STAFF RECOMMENDATION

1016 15th Avenue South

February 17, 2021

Application: New Construction – Infill and Outbuilding
District: Edgehill Neighborhood Conservation Zoning Overlay
Council District: 17
Base Zoning: R6-A
Map and Parcel Number: 105 01 0 167.00
Applicant: Mitch Hodge
Project Lead: Jenny Warren, jenny.warren@nashville.gov

Figure 4. Site plan

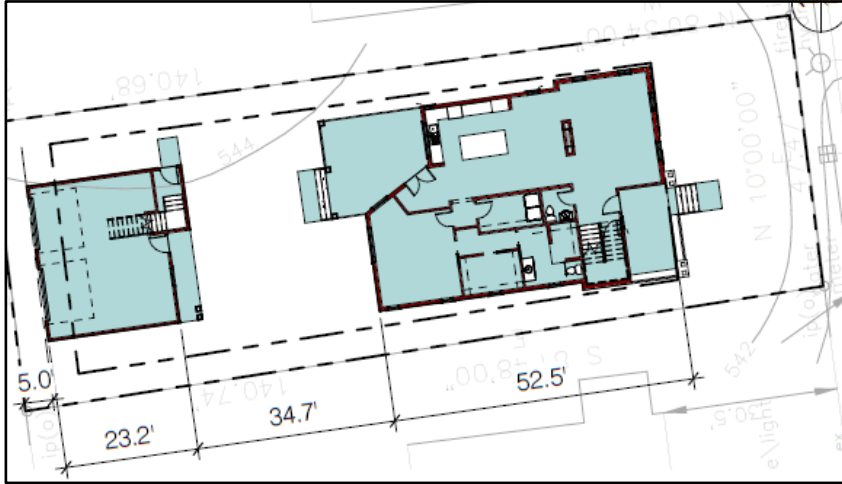
Setback & Rhythm of Spacing: The front setback is proposed to be about twenty-five feet (25') from the front property line. This will align the front wall of the infill with the front wall of the historic house to its right; and will roughly match the front setback of the next two historic houses to the right. The house to the left sits about thirty feet, six inches (30'6") from the property line; but is non-contributing. The infill will roughly align with the setback of the historic house two doors down on the left.

The side walls will be about six feet (6') from the side property lines at the closest points. This meets the base zoning setbacks of five feet (5'). However, as discussed above, the houses on this block are all narrower than forty feet (40') – with the two-story houses being twenty-eight to thirty-three feet (28'-33') wide - and they all sit on fifty-foot (50') lots. This means that the typical rhythm of spacing on this block includes a greater separation between houses than what would be permitted by base zoning. For example, as indicated on the submitted site plan, the historic house to the immediate right is thirty-two feet (32') wide and sits about nine feet, six inches (9'6") from the shared property line. Staff finds that reducing the width of the house to thirty-two or thirty-three feet (32'-33') will not only create a more compatible massing, but will also better match the rhythm of spacing on the street.

The back wall will be more than fifty feet (50') from the rear property line.

Orientation: The house is oriented to the street. There is a front porch which is eight feet (8') deep and includes columns with bases and capitals. A walkway to the sidewalk should be added to the site plan.

Staff finds that with the condition that the width of the house is reduced to be no more than thirty-two or thirty-three feet (32'-33') wide, the project's setback and rhythm of spacing will meet Section III.C. of the Edgehill design guidelines.

With the addition of a walkway to the sidewalk, staff finds that the project's orientation meets Section III.F. of the Edgehill design guidelines.

Figure 7. Alley and yard-facing elevations of outbuilding

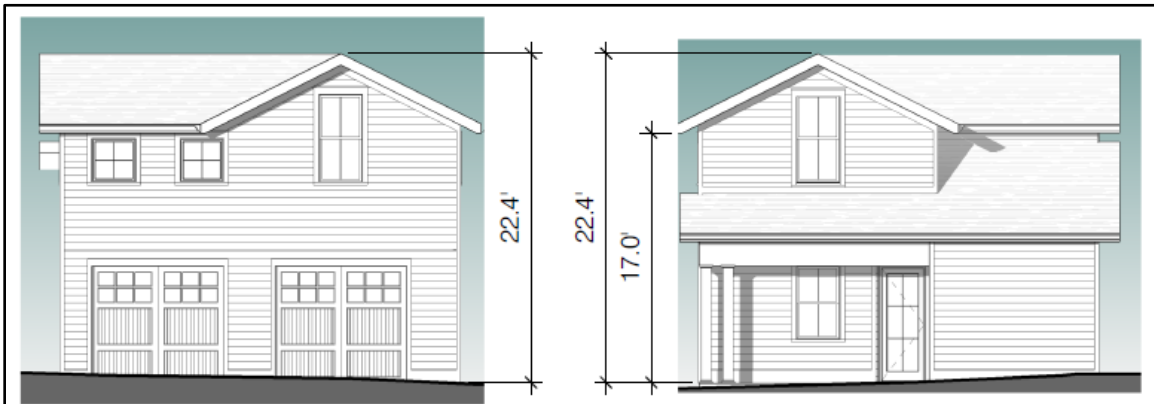
Outbuilding: The applicant is planning a two-story outbuilding in the rear yard.

The eave and ridge heights are appropriate.

At seven-thousand, one-hundred-eighty-eight square feet (7,188 sq ft), the lot is limited to an outbuilding footprint of seven-hundred-fifty (750) square feet. The proposed seven-hundred-thirty (730) square feet is appropriate.

Lap siding is indicated. It should be smooth with a maximum five inch (5”) reveal. With the staff’s final approval of the foundation material, cladding, roof color, the trim material, porch post, windows and the pedestrian and garage doors, staff finds that the known materials meet Sections IV. C and D of the design guidelines for materials, windows and doors.

Staff finds that the outbuilding's massing meets Section IV. A of the design guidelines.

Since the form and slope is similar to historic outbuildings, staff finds that the outbuilding meets Section IV. B of the design guidelines.

Staff finds the proposed outbuilding meets Section IV. of the Edgehill design guidelines for outbuildings and ordinance 17.16.030 for detached accessory dwelling units.

3 FRONT
3
1" = 10'-0"

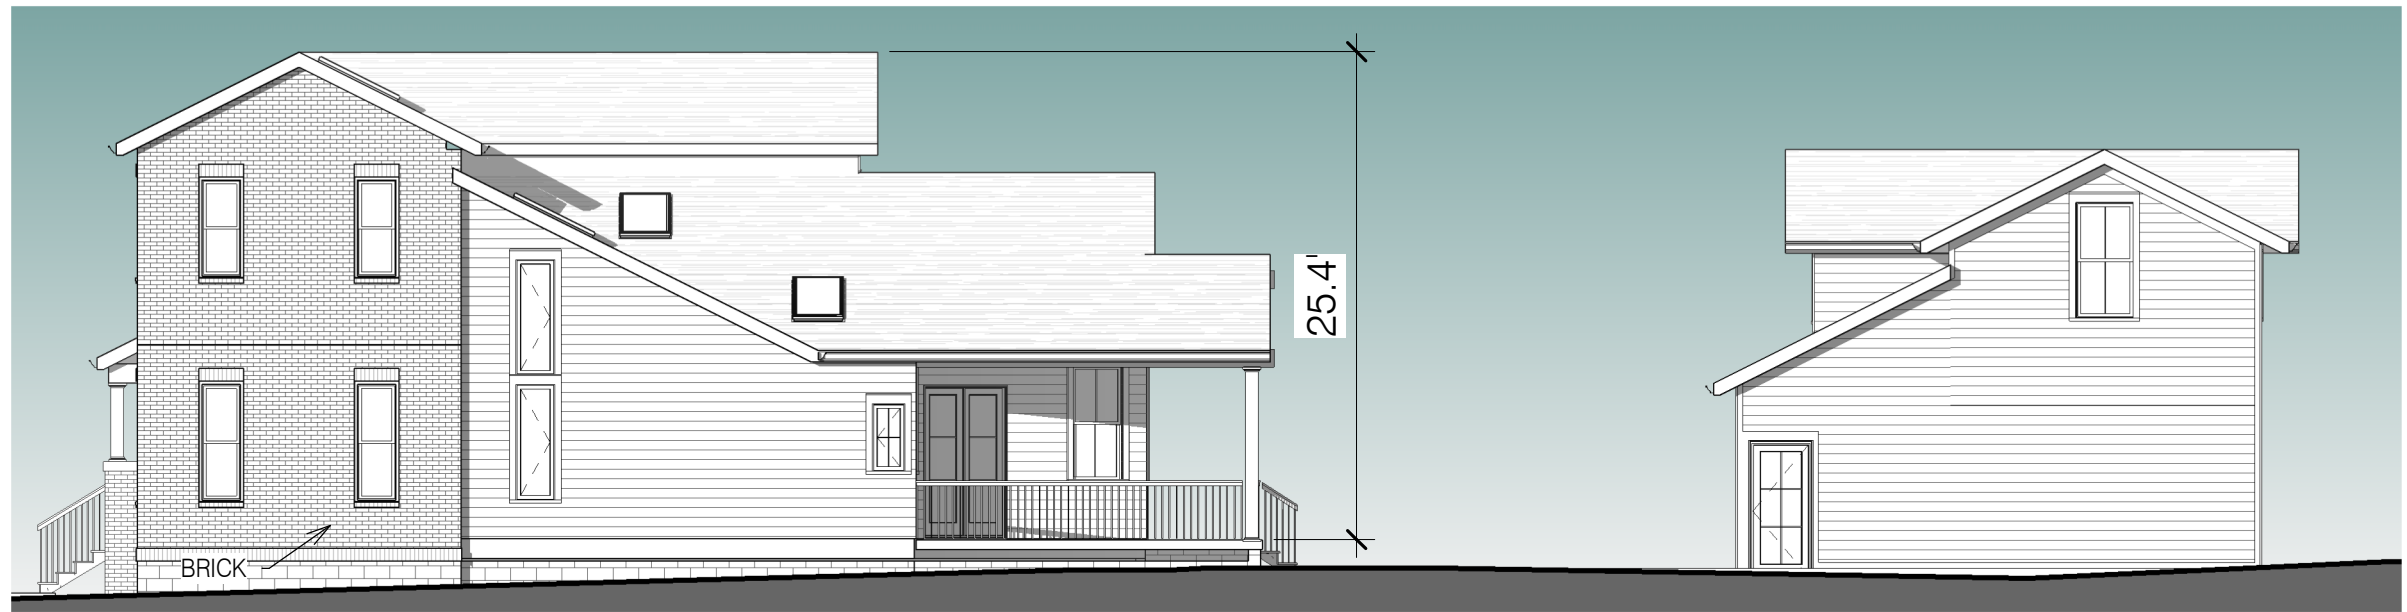
The proposed infill has a width of just under thirty-seven feet (37') wide. The widths of historic two-story houses in the immediate context range from about twenty-eight feet to about thirty-three feet (28'-33'). There are a few wider houses – ranging from thirty-six to forty-two feet (36'-42') wide but these are all one and one-and-a-half story houses with much lower eaves and ridge heights around twenty-three feet (23') tall. Staff finds that with a two-story form and twenty-two foot, six inch (22'6") eaves, the maximum appropriate width for the context is about thirty-two to thirty-three feet (32'-33') – which matches the width of the wider two story houses on the block. See Figure 3. The

proposed thirty-seven feet (37') of width combined with the twenty-eight foot (28') height, will create a house with overall massing greater than anything in the historic context. The width of the design should be reduced to be no more than thirty-two or thirty-three feet (32'-33') at the front.

The windows on the proposed infill are generally twice as tall as they are wide, thereby meeting the historic proportions of openings. On the front elevation, the second story windows are slightly shorter than those on the first story, which is appropriate as well. There are no large expanses of wall space without a window or door opening.

Staff finds that the project's height meets Section III.A., and that with the condition that the width of the design is narrowed to be no more than thirty-two or thirty-three feet (32'-33'), the scale could meet Section III.B. of the Edgehill design guidelines.

Staff finds the project's proportion and rhythm of openings meet Section III.G. of the Edgehill design guidelines.
